## ADDENDUM

Date February 2, 2024

Re Addendum No. 3 to the Construction Documents for:

Dorthea Dix Psychiatric Campus  
Pooler Pavilion Abatement  
Bangor, Maine  
Project No. 23134

## RPF ABATEMENT ACM MARK-UP ADDENDUM #3

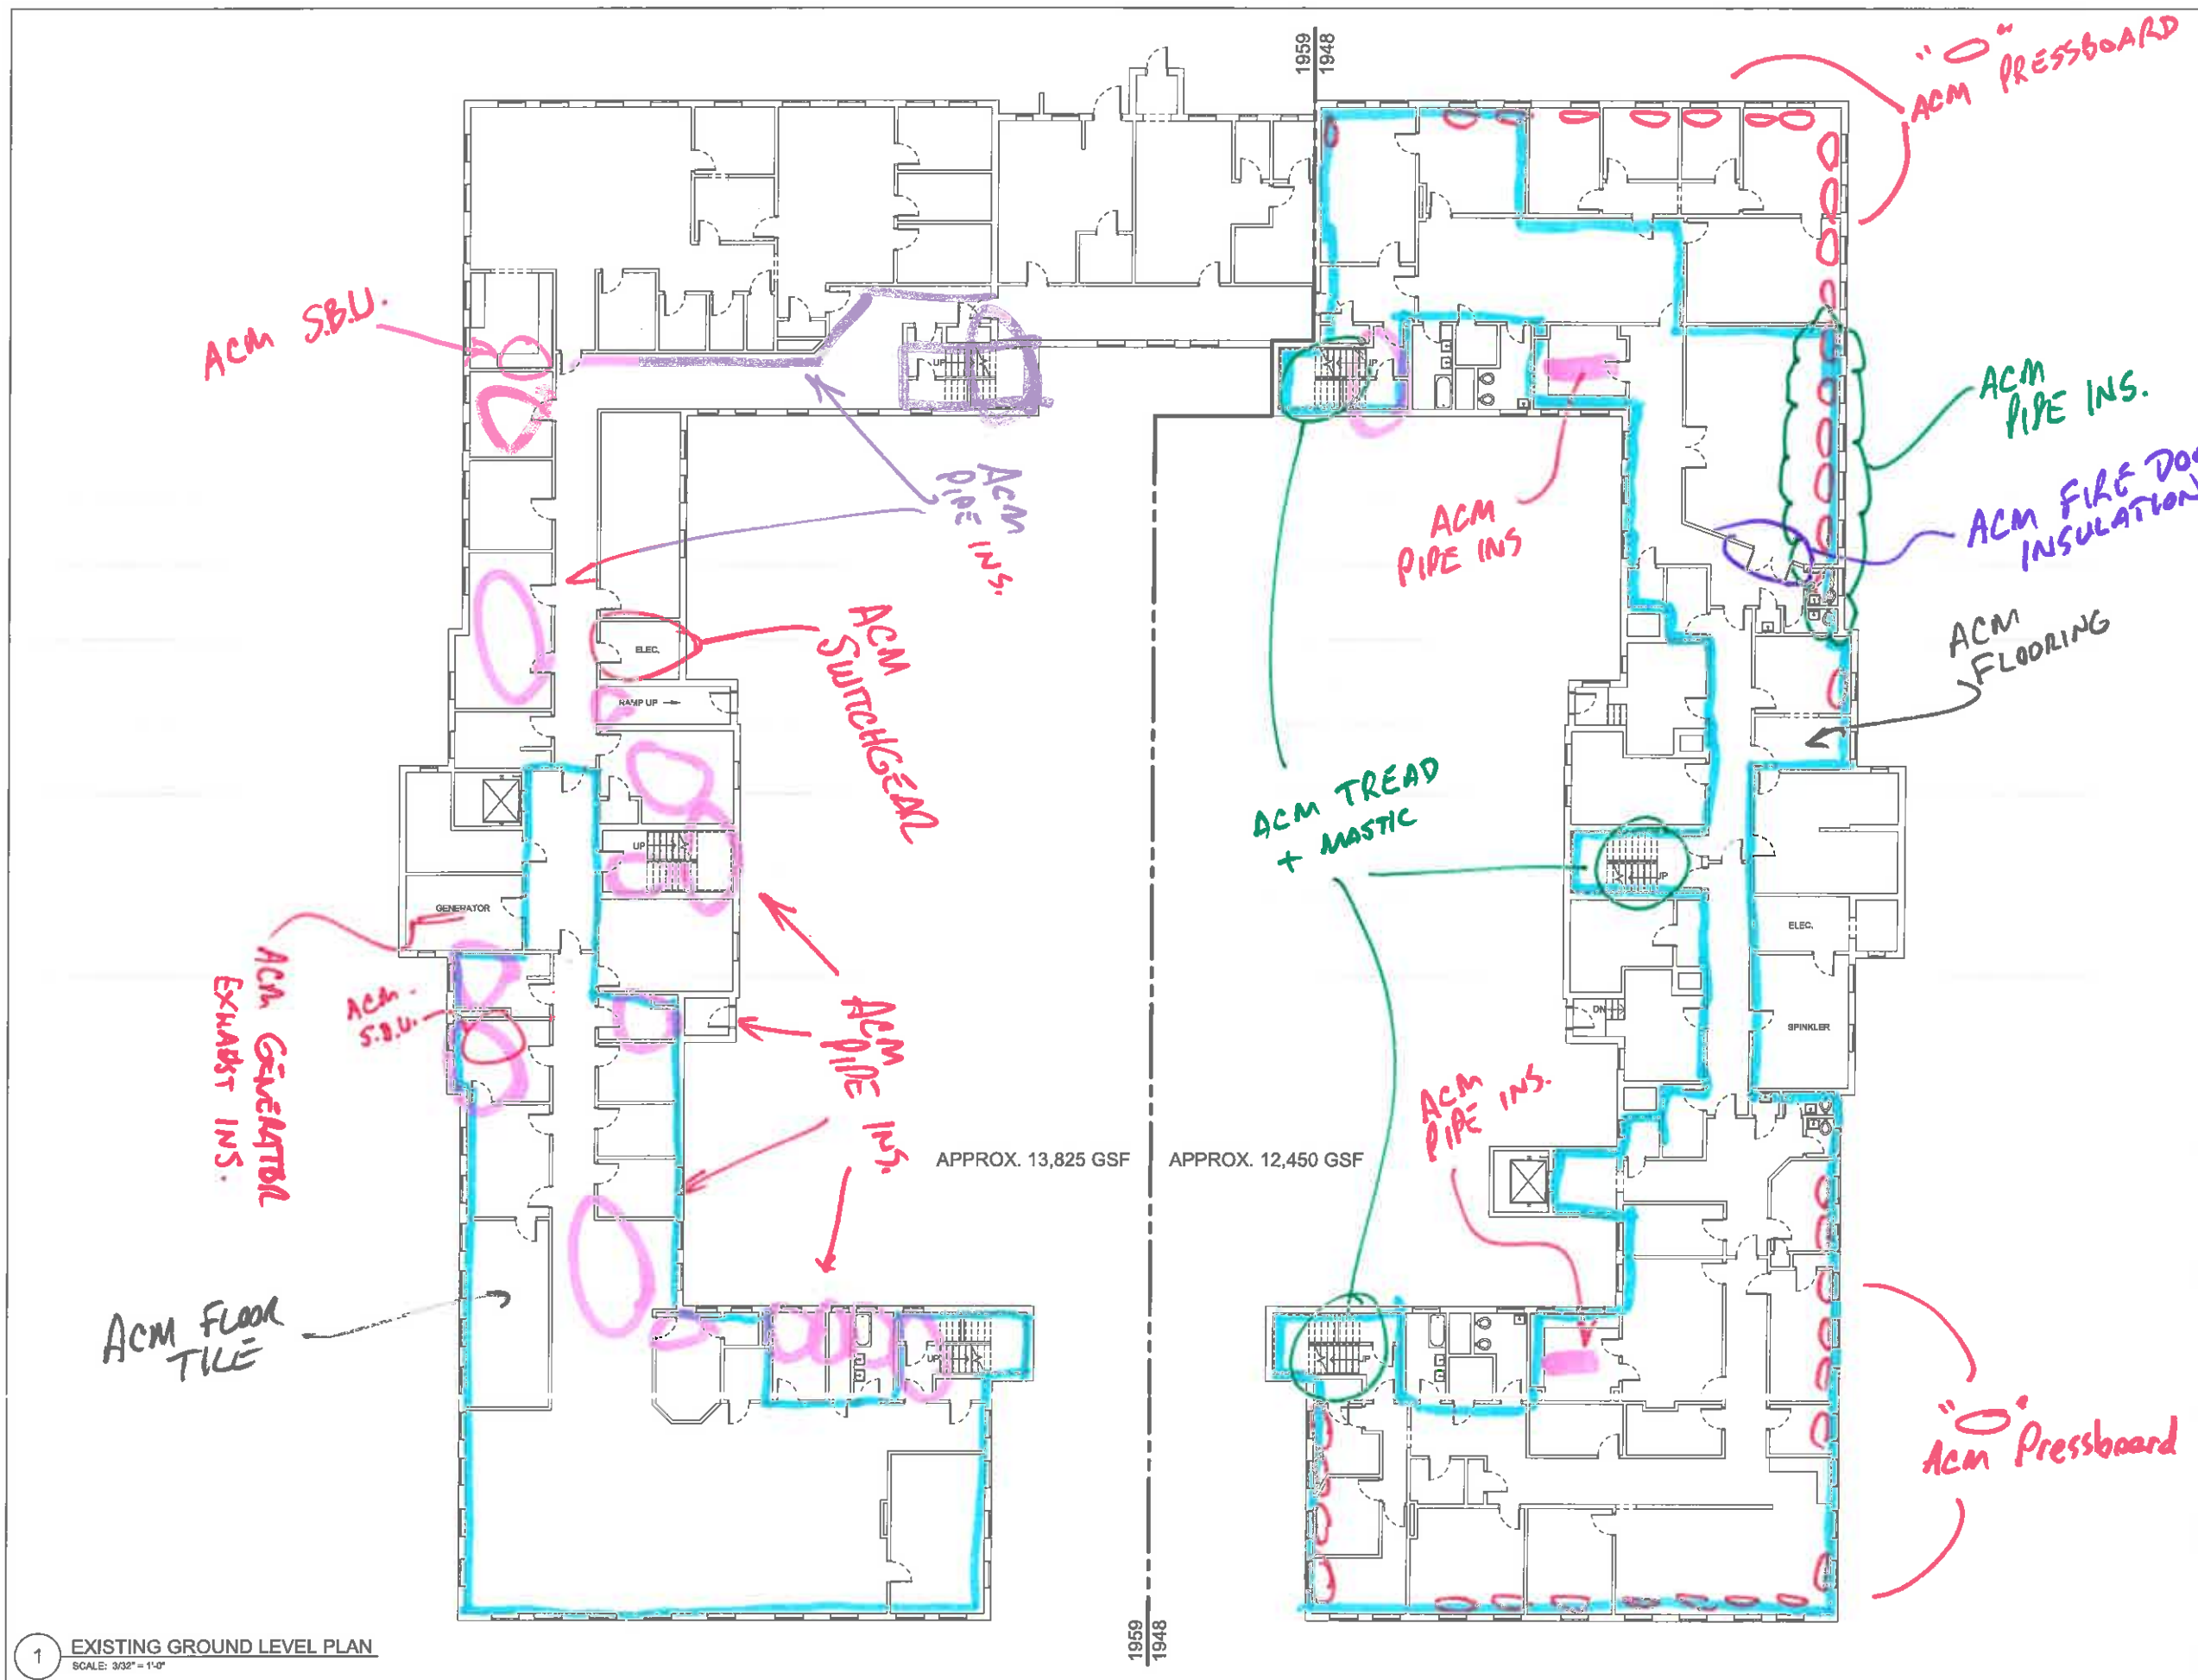
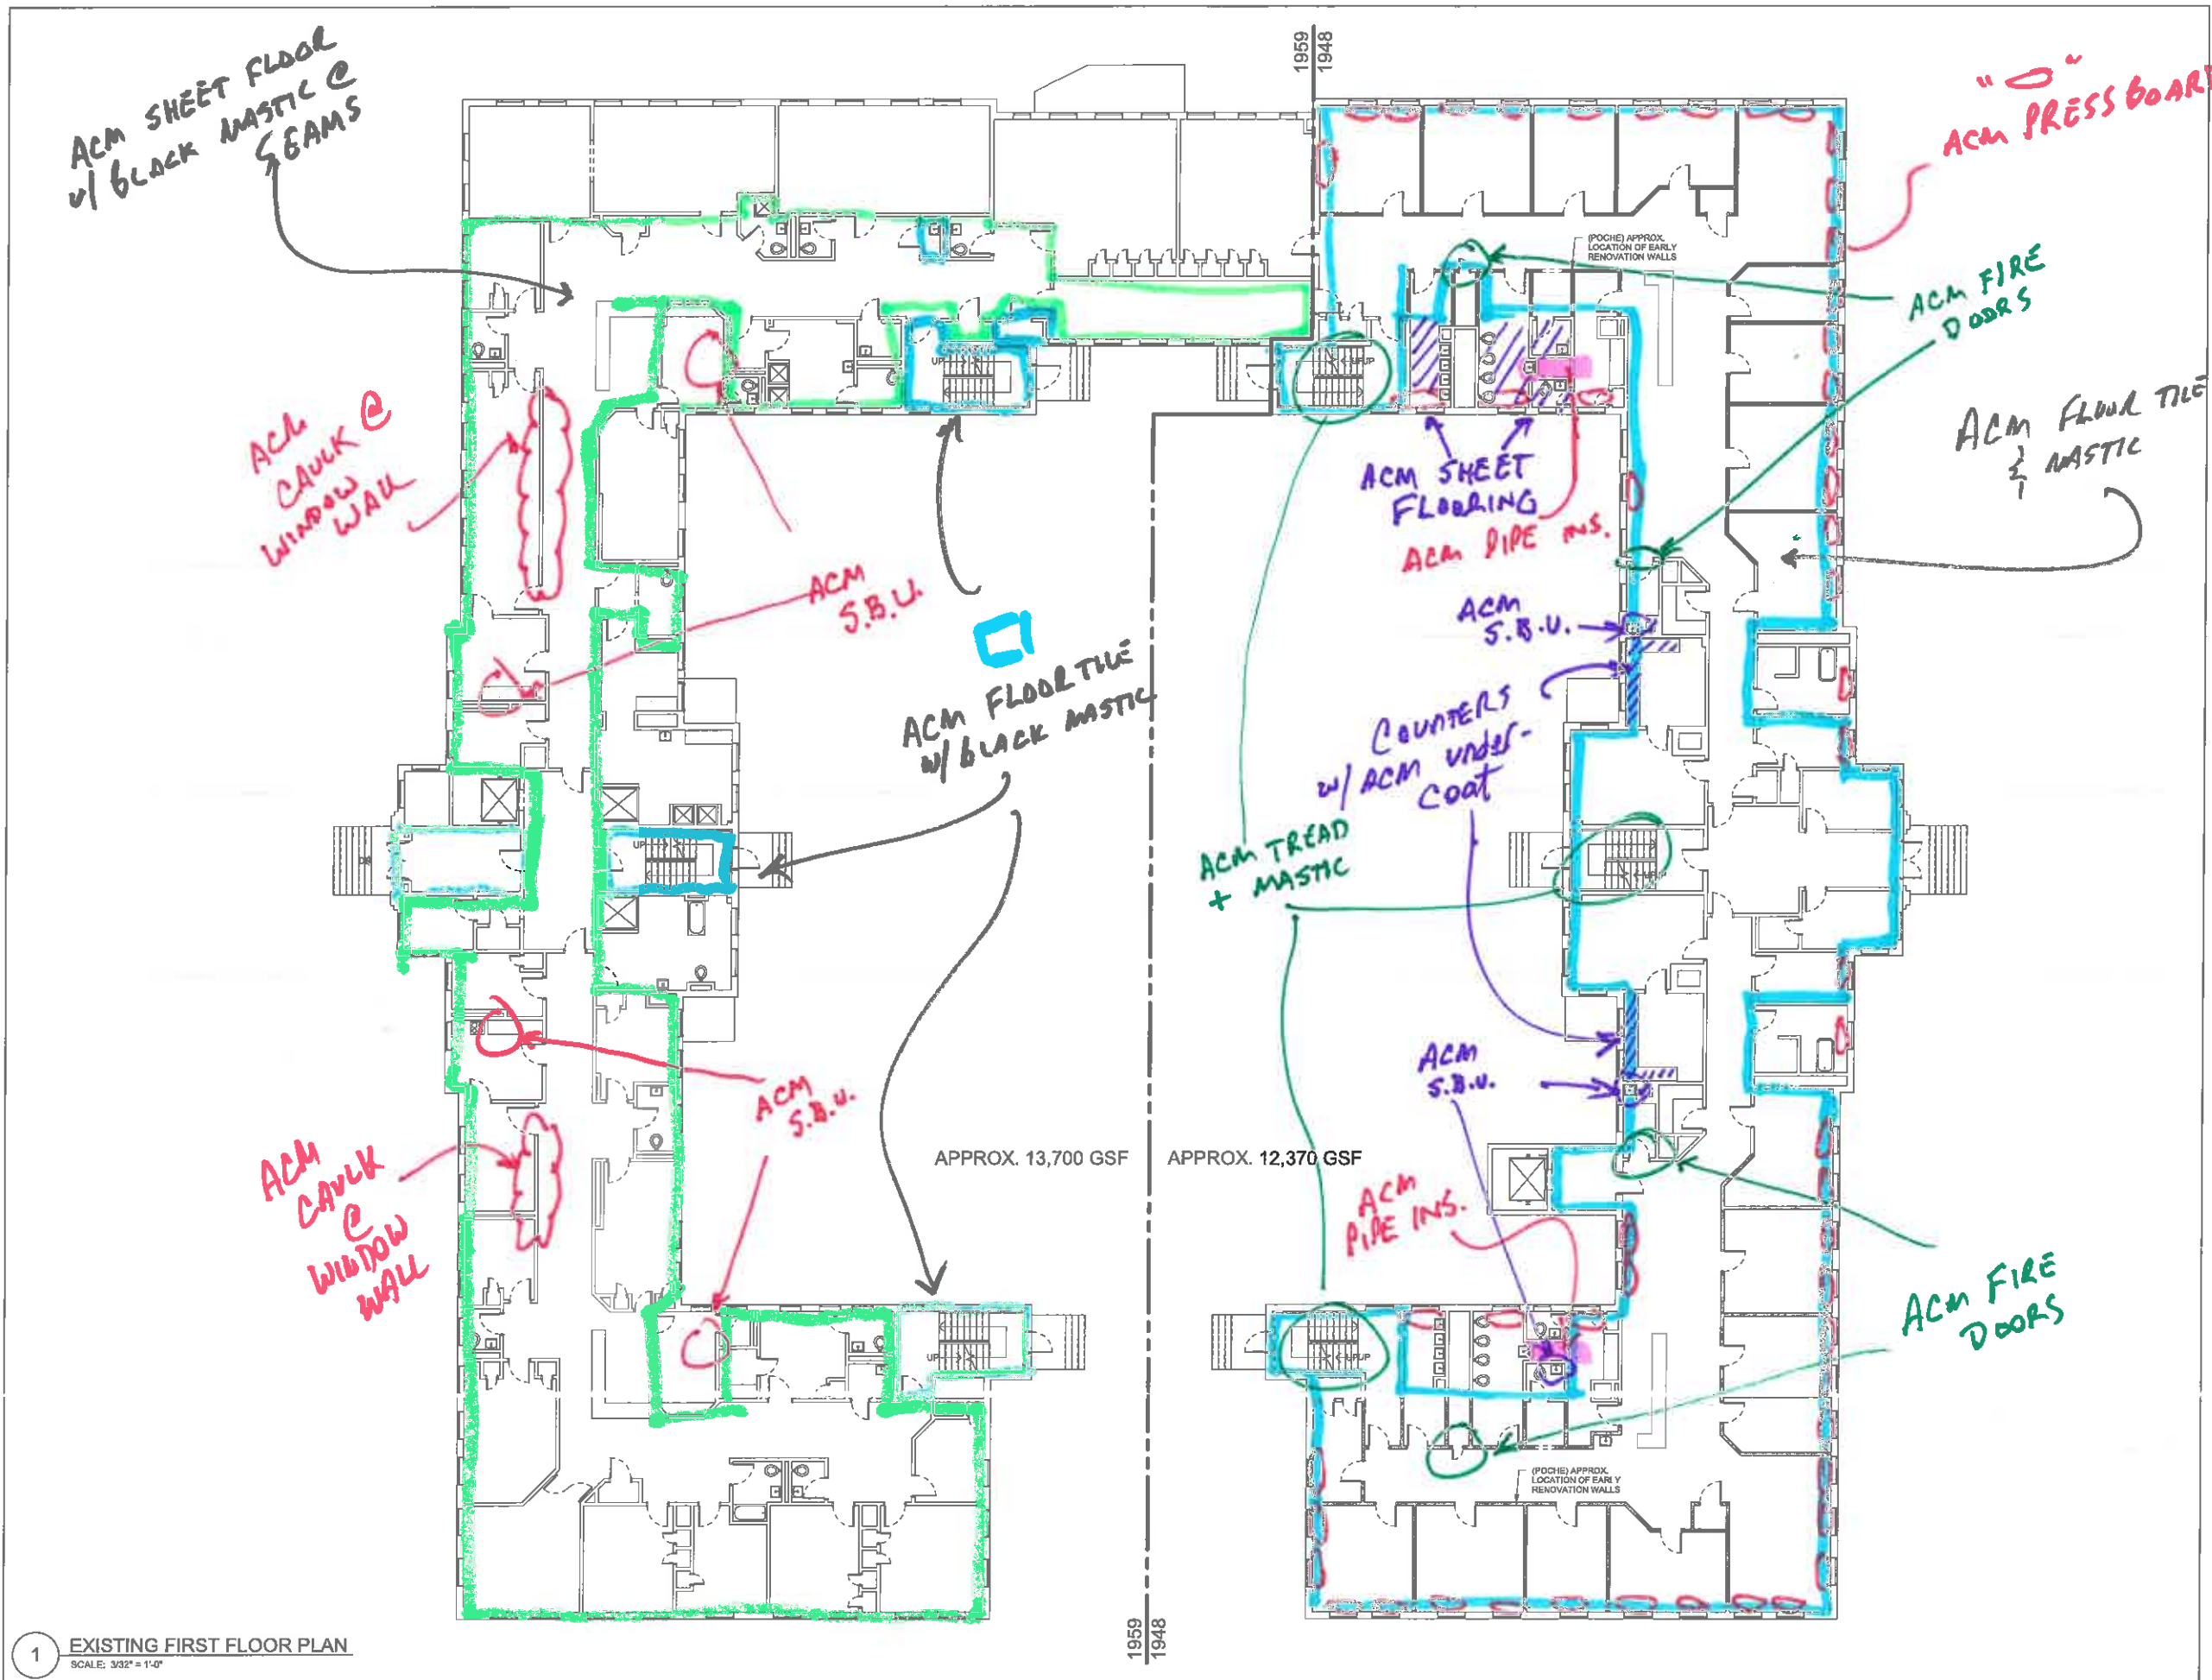
Q2: The RPF survey provides a summary of ACM to be removed called Table 1. Can you please provide a floorplan clearly identifying the locations of these asbestos containing materials?

Q3: At the prebid conference it was apparent a significant amount of interior walls have been built atop the asbestos containing flooring. Will you provide bidders with a way to quantify the amount of walls to be demolished to perform the asbestos abatement work?

Q4: At the prebid conference it was apparent a significant amount of asbestos flooring is present below other non-asbestos carpet or non-asbestos VCT tile. In some cases the asbestos layer is the bottom of three layers. Will you provide bidders with a way to quantify which flooring areas are single layer, double layer, and triple layer flooring?

Q9: Can a color-coded diagram of the floor surfaces requiring abatement be provided? OR shall the abatement contractor assume all floor mastics must be removed?

- Q28: What is the extent of the asbestos pipe insulation located within the building? There appears to be greater than 2,500 LF of pipe inside the new building.

**A2: See attached floor plan documents issued for reference with this Addendum.**

**A3: See attached floor plan documents issued for reference with this Addendum. The walls noted are approximate locations and quantities.**

**A4: See attached floor plan documents issued for reference with this Addendum. Much of the ACBM flooring is exposed and not covered by other flooring. The bidders have had the opportunity to see the areas of abatement and make determinations of what ACBM may be covered. Quantification of materials is the responsibility of the bidder.**

**A9: See attached floor plan documents issued for reference with this Addendum.**

**A28: See attached floor plan documents issued for reference with this Addendum.**
- Q29: In an effort to eliminate a change order to the State of Maine, will the abatement contractor own all demolition to access and removal and disposal of all floor finishes, mastics, & pipe insulation located above grade within the building?
